Development Description: Demolition of an existing commercial two storey building and the construction of 2 commercial units with Plantroom on Ground floor level with 8 residential apartments comprising 2 one Bed apartments 3 two bed apartments and 3 three bed apartments all with private balconies over 4 floors; A communal roof garden is located on the fourth floor; Enclosed bin stores for the commercial and residential units is located at the rear of the building; 5 total car parking spaces including 1 disabled car space is provided; 8 bicycle spaces are provided at the front for commercial units and 10 no. bicycle spaces at the rear for residential units; Sustainable drainage (SuDs) roof and roof garden are provided for the development and all associated engineering and site works necessary to facilitate the development.

Development Address: Paintworld, 1-2 Ballymount Road Lower, Dublin 12

Planning Reg. Ref.: SD22A/0406

Response to Request for Further Information

Figure 6: Green Infrastructure and Masterplan Concept for the Wider Area

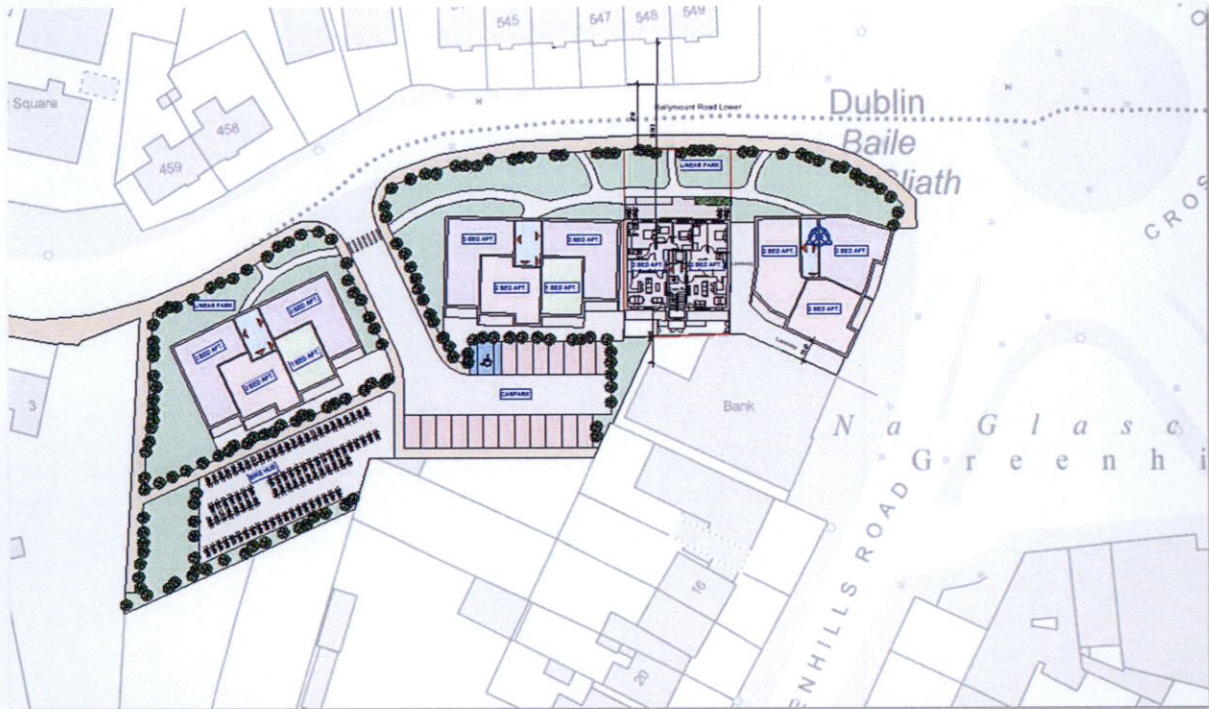
e) The masterplan submitted only relates to the existing commercial strip along Ballymount Road Lower, suggesting that neighbouring units could be developed in a similar piecemeal fashion, with parking courts to the front creating multiple accesses onto Ballymount Road Lower, extending the full

depth of sites and providing no public open space. This masterplan is considered inadequate insofar as it does not consider the potential to incorporate development along Greenhills Road, and how development along Ballymount Road Lower must protect the development potential of the lands to the south. Redevelopment proposals should enhance the current situation. The applicant may wish to consider further site assembly or work with other neighbouring properties to develop a more robust masterplan that could be implemented and would meet the requirements of the development plan. In doing so, the applicant may wish to consider locating car parking to the rear of the building and develop lands along both Ballymount Road Lower and Greenhills Road in tandem.

We acknowledge the laudable proposal by the planning authority that we engage local landowners in the vicinity of the site and together provide for a Masterplan of the wider area. However, opportunity for site assembly and our agency over third-party land, which is neither in our ownership or control, is limited. Without statutory powers to create a binding plan, including ensuring public right of participation in the plan making process and appropriate environmental assessment under the applicable directives (including SEA and AA), we consider such a proposal would have minimal practical effect, application or influence.

We consider investment in the subject site does have potential to act a catalysis for investment and redevelopment of the area by setting a benchmark of quality design by which others can follow. In particular, there are a number of derelict and underutilised sites in the area, meaning there is a good opportunity for the Council to spearhead such an initiative, which would then become a material consideration for other sites as they are brought forward for planning. We agree that the subject site and surrounding area provides a key strategic opportunity centrally within Walkinstown to improve the urban realm in particular to support a move away from car-based transport. Accordingly, we have set out a concept Masterplan (figure x below) showing how the proposed site might sit within the wider area, which could be given some consideration as part of any plan making process.
